Battery Terminal Corrosion CXU

FSB 313-001, Battery Terminal Corrosion

February 2012

W3071682

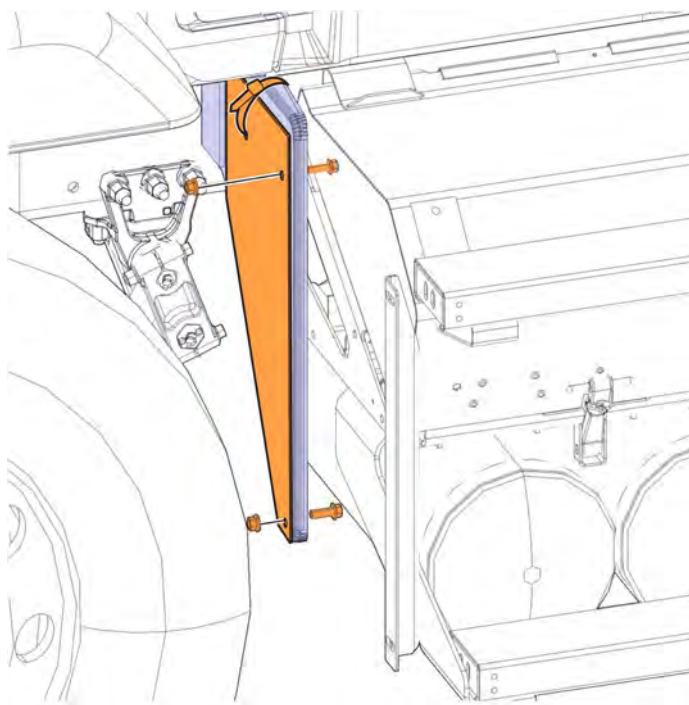
On certain CXU models equipped with the three battery box design, the battery terminals have corroded due to contaminants splashing directly onto the batteries. The left front fender splash shield bracket has a triangular shaped hole in it that is in line with the 3 battery box. Perform the shield installation below to correct the condition.

- 2 Remove the inside (upper & lower) fasteners on the left side splash shield.
- 3 Install part number 82723124 into position as shown in the illustration. Start both fasteners and loosely tighten.

Note: The new part slides in between bracket and splash shield for proper installation.

- 4 Finish tightening both fasteners and torque to specifications, see Group 30
- 5 Install cable tie through the remaining hole in shield part number 82723124 and wrap around bracket to secure.
- 6 Install battery box cover.
